QUALITY ASSURANCE -- NON-CONFORMANCE REPORT

Location: Changxing Island **Report No:** NCR-000368
Prime Contractor: American Bridge/Fluor Enterprises, a JV **Date:** 19-Jun-2009
Submitting Contractor: Zhenhua Port Machinery Company, Ltd (ZPMC), Changxing Island **NCR #:** ZPMC-0342

Reference Description: Buttering of FB and SP of CB 5

Job Name: SAS Superstructure
Document No: 05.03.06-000321

Draft of Welding Discontinuity:

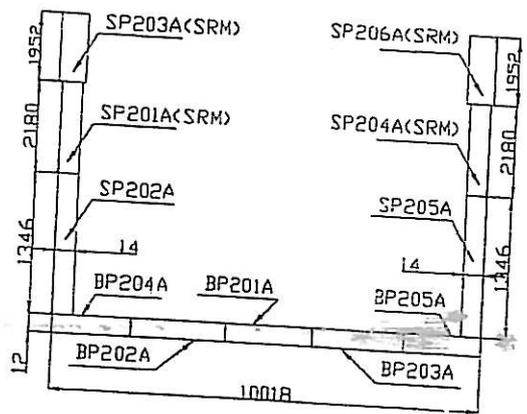
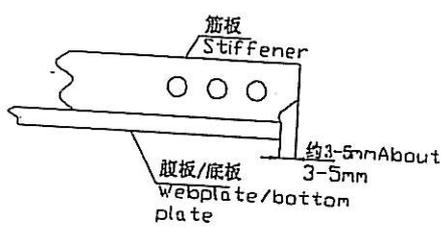
CB5已修割余量的底板BP204A, BP202A, BP201A, BP203A, BP205A, 腹板SP202A, (SP205A)比I肋短了约3-5mm, 且筋板有割伤。
CB5 bottom plate (BP204A, BP202A, BP201A, BP203A, BP205A), web plate (SP202A, SP201A, SP203A, SP204A, SP206A, SP205A) was 3-5mm shorter than T-shape, and the stiffeners were gouged after cutting, see the following draft.

注: 图中
SP202A, SP205A, BP201A, BP202A, BP203A, BP204A, BP205A
7块板单元为SPCM板
Remark: SP202A, SP205A,
BP201A, BP202A, BP203A, BP204A, BP205A
were SPCM component

1. The Engineer shall be notified and present during this repair. Indicate repair procedure;
2. QC and a Lead CWI shall be present and direct all grinding and welding operations during this repair.
3. QC and a Lead CWI shall have an approved copy of the CWR in hand prior to the repair.
4. QC and a Lead CWI shall direct the repair to ensure the repair is per the disposition requirements.
5. Perform hardness testing at repair area and base metal laying above cracks, provide verbal and written notification to Engineer prior to performing hardness testing, and submit the testing result to Caltrans for review prior to repairing after testing.

1. Prepare excavation with relevant WPS.
2. VT to verify repair area is free of all defects.
3. Add steel backing at the back of groove according to AWS D1.5.3.13;
4. Preheat and weld according to the relevant WPS.
5. Gouge off the steel backing and grind the weld flush with base metal after welding;
6. Perform NDT inspection (VT, UT and MT) to the repaired welding according to the relevant requirement. UT and MT must be performed for SRM members in accordance with Section 3.2.2.3 of AWS D1.5 after repair.

1. Prepare excavation with relevant WPS.
2. VT to verify repair area is free of all defects.
3. Preheat and weld according to the relevant repaired WPS.
4. Grind the weld flush with base metal after welding;
5. Perform NDT inspection (MT) to the repaired welding according to the relevant requirement. UT and MT must be performed for SRM members in accordance with Section 3.2.2.3 of AWS D1.5 after repair.

Draft of Welding Discontinuity:

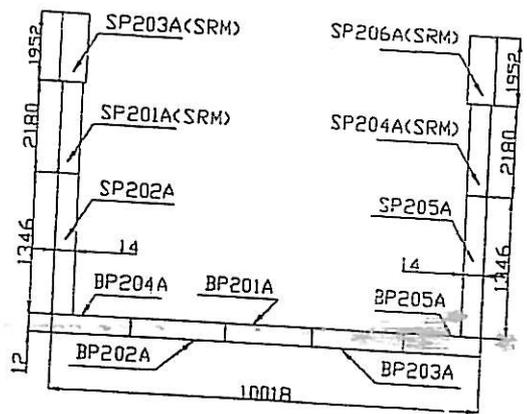
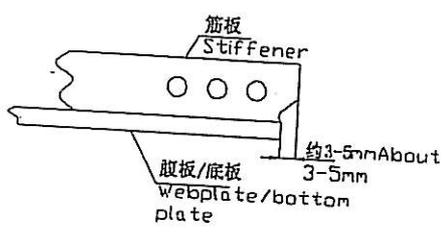
CB5已修割余量的底板BP204A, BP202A, BP201A, BP203A, BP205A, 腹板SP202A, (SP205A)比I肋短了约3-5mm, 且筋板有割伤。
 CB5 bottom plate (BP204A, BP202A, BP201A, BP203A, BP205A), web plate (SP202A, SP201A, SP203A, SP204A, SP206A, SP205A) was 3-5mm shorter than T-shape, and the stiffeners were gouged after cutting, see the following draft.

注: 图中
 SP202A, SP205A, BP201A, BP202A, BP203A, BP204A, BP205A
 7块板单元为SPCM板
 Remark: SP202A, SP205A,
 BP201A, BP202A, BP203A, BP204A, BP205A
 were SPCM component

1. The Engineer shall be notified and present during this repair. Indicate repair procedure;
2. QC and a Lead CWI shall be present and direct all grinding and welding operations during this repair.
3. QC and a Lead CWI shall have an approved copy of the CWR in hand prior to the repair.
4. QC and a Lead CWI shall direct the repair to ensure the repair is per the disposition requirements.
5. Perform hardness testing at repair area and base metal laying above cracks, provide verbal and written notification to Engineer prior to performing hardness testing, and submit the testing result to Caltrans for review prior to repairing after testing.

1. Prepare excavation with relevant WPS.
2. VT to verify repair area is free of all defects.
3. Add steel backing at the back of groove according to AWS D1.5.3.13;
4. Preheat and weld according to the relevant WPS.
5. Gouge off the steel backing and grind the weld flush with base metal after welding;
6. Perform NDT inspection (VT, UT and MT) to the repaired welding according to the relevant requirement. UT and MT must be performed for SRM members in accordance with Section 3.2.2.3 of AWS D1.5 after repair.

1. Prepare excavation with relevant WPS.
2. VT to verify repair area is free of all defects.
3. Preheat and weld according to the relevant repaired WPS.
4. Grind the weld flush with base metal after welding;
5. Perform NDT inspection (MT) to the repaired welding according to the relevant requirement. UT and MT must be performed for SRM members in accordance with Section 3.2.2.3 of AWS D1.5 after repair.
